TWR-K60N512 Tower Module

Hardware Errata and Changes

Rev. 0

TWRK60N512_01: Infrared Detector Isolation

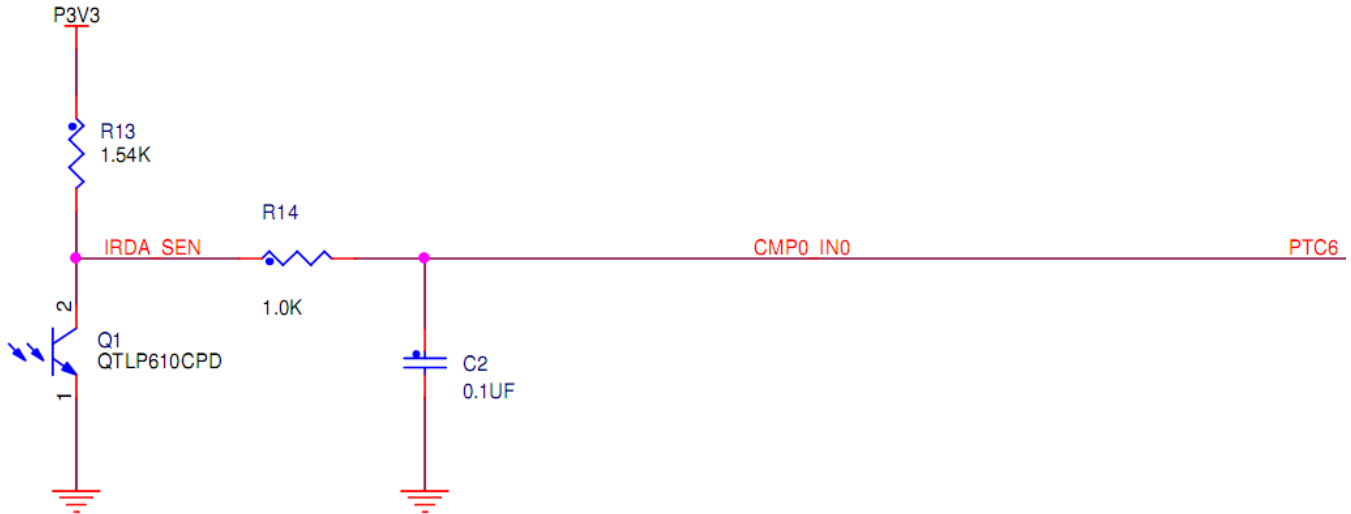
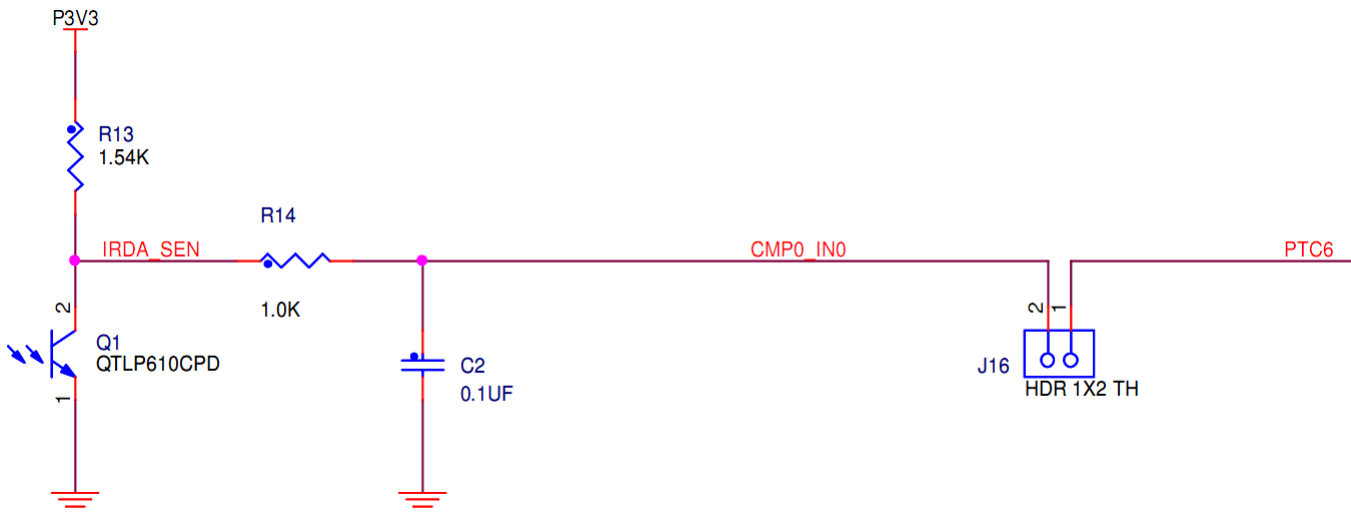
The PTC6 is multiplexed with FB_AD9 and CMP0_IN0. Both of these functions are used on the TWR-K60N512: PTC6 is connected to the infrared receiver circuit and also to the Flexbus interface on the Primary Connector. This dual-usage can lead to contention and interference.

To avoid interference on the Flexbus signal, R14 and C2 can be removed.

A jumper to isolate the infrared received circuit was added to revision D of the schematics.

TWRK60N512_02: JTAG TMS Pull-up Resistor

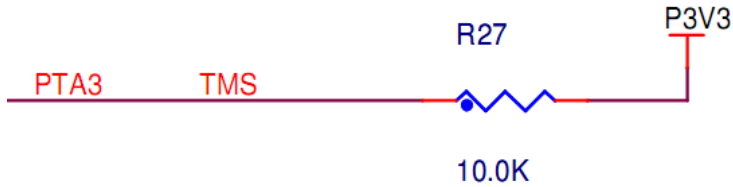
The pull-up resistor on the TMS signal is too strong and doesn't follow the JTAG standard.

Replace R27 with a 10K resistor.

The value of R27 was changed to 10.0K ohms starting with revision D of the schematics.

TWRK60N512_03: Lack of Reset Output

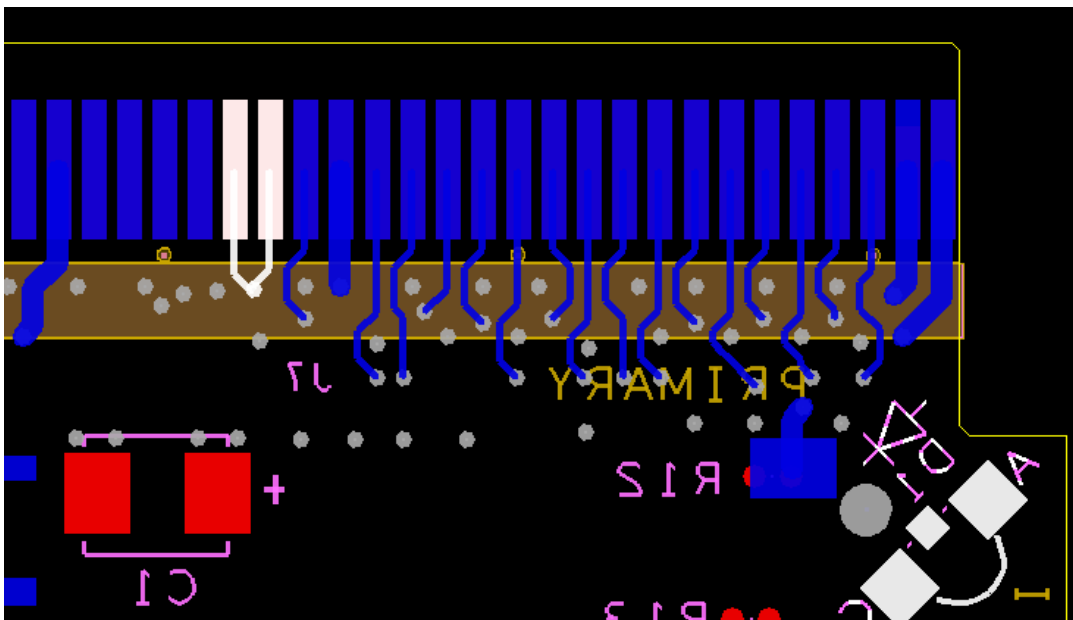
The RSTOUT pin on the Elevator Primary Connector (A63) is connected to the RSTIN pin (A62) which is connected to RESET_B on the MCU. There is no way for the MCU to control the RESET_B pin in GPIO mode so that it can drive RSTOUT to other Tower Peripheral Modules. Some ICs on Tower Peripheral Modules need to be independently reset as part of their initialization sequence (e.g. the LCD controller on the TWR-LCD).

There is no easily implemented workaround for this erratum. It is possible to cut the trace connecting RSTOUT (bottom side of PCB, shown as the highlighted pin on the right in the figure below) to RSTIN and solder a wire from the pad to an available GPIO pin from the K60 MCU. Care must be taken when soldering to the pad not to interfere with the ability to plug the card into a TWR-ELEV board.

PTE27 is used to drive RSTOUT on revision D of the schematics. However, PTE27 is also used as the GPIO7/SD_WP_DET signal—pin A11 on the Primary Elevator. This introduces possible interference with SD Cards and peripheral modules that utilize GPIO7. See *TWRK60N512_05: GPIO7/PTE27 and RSTOUT Interference*.

TWRK60N512_04: Potentiometer Voltage Reference

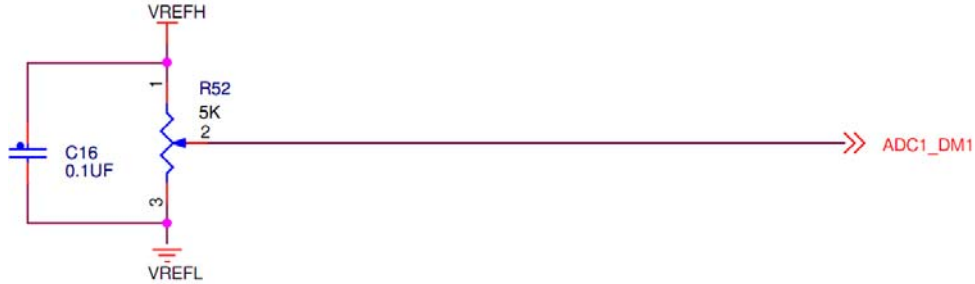
The potentiometer is connected between VREFH and VREFL. These supplies are derived from the P3V3_MCU. The potentiometer works as expected but the supply connection loads the processor voltage rail and limits the ability to measure the power consumed by only the MCU.

The potentiometer can be removed to measure the current consumed by only the MCU.

Starting with revision D of the schematics, the supply voltage to the potentiometer was changed.
